STATE OF NEVADA  
Department of Conservation & Natural Resources  
DIVISION OF ENVIRONMENTAL PROTECTION

**Subject:** Draft Work Plan for Mitigation of Indoor Air and Well Water (dated June 28, 2011)  
**Facility:** Al Phillips the Cleaner (former)  
3661 S. Maryland Parkway  
Las Vegas, NV  
**Facility ID:** H-000086

### COMMENTS FOR THE ADMINISTRATIVE RECORD Work Plan for Mitigation of Indoor Air and Groundwater, dated June 28, 2011

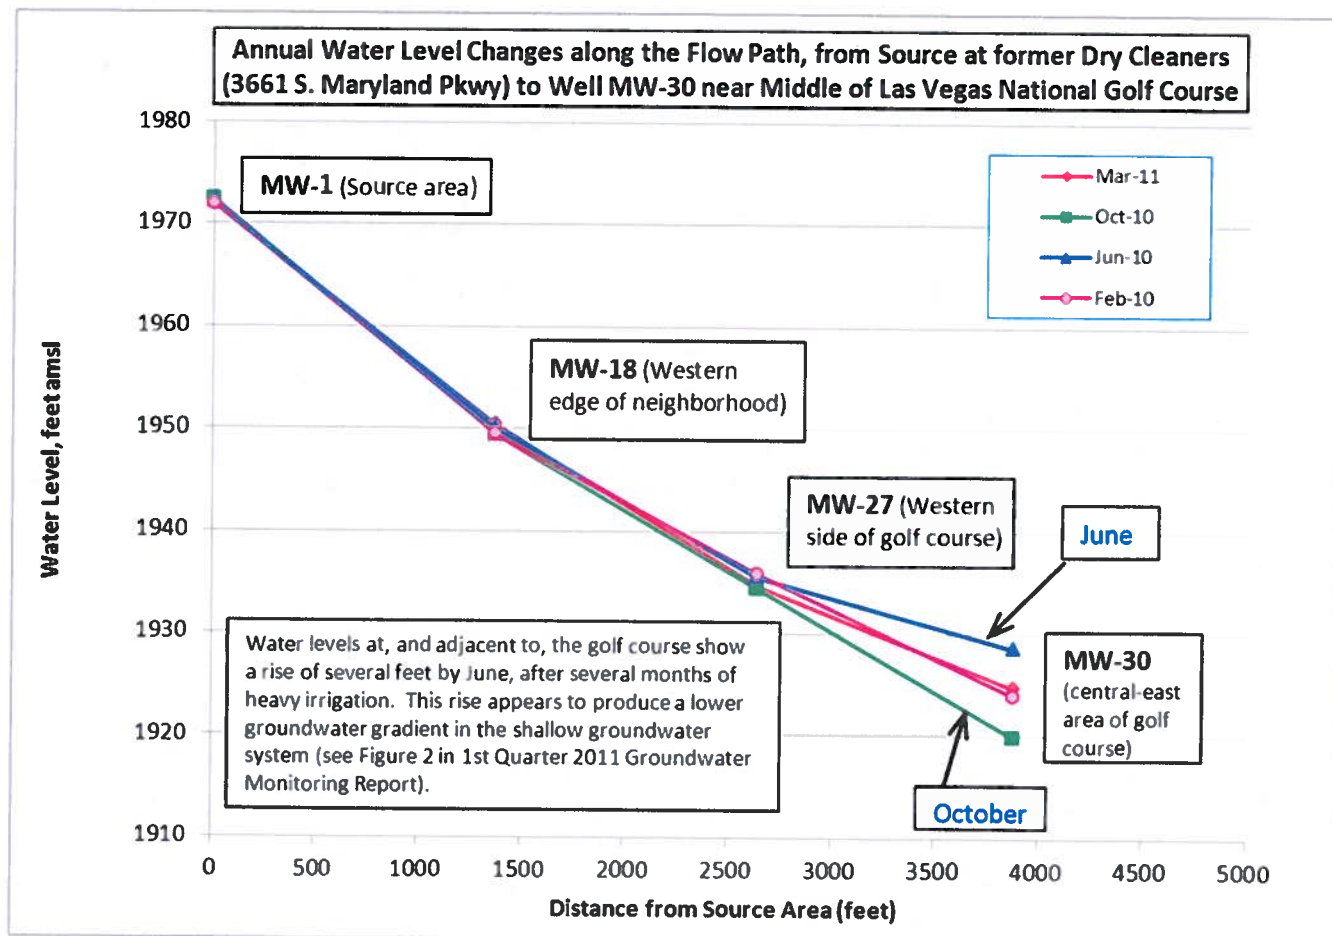
1. RTCs #1, #7. Although the response states that Figure 1.1 has been updated, it hasn't. The 3<sup>rd</sup> Quarter 2010 data (October 2010) are still used to draw the concentration contours. See, for example, data posted for well MW-26. (Note: Sections 1.0 and 1.2 of the Work Plan reference Figure 1-1).

1. **Figure 1-1** shows concentration contours based on 3<sup>rd</sup> Quarter, 2010 data (i.e., data collected October, 2010), but the footnote to this figure states that data are from 4<sup>th</sup> Quarter, 2010.

Perhaps a more representative Figure 1-1 could show the average concentrations for recent samples (e.g., all data for 2009 to present) from each well. Such averaged data would provide a figure not seen in the quarterly reports. This concept has been previously discussed and this may be the best document to contain such a figure.

11. NDEP Comments 1 and 7 and Figure 1.1. Although the responses to NDEP Comments 1 and 7 agree to the change, the plume contours in Figure 1-1 still reflect data for 3<sup>rd</sup> quarter 2010. That is, contrary to the footnote on Figure 1-1, the data shown are for the 3<sup>rd</sup> quarter 2010.

12. Figure 1-1 brings up an interesting point that has been verbally discussed; that is, using some form of the "average" concentration to draw the plume contour. Although the NDEP does not think this is appropriate for the quarterly reports, this concept may be useful for the IAWW work plan.
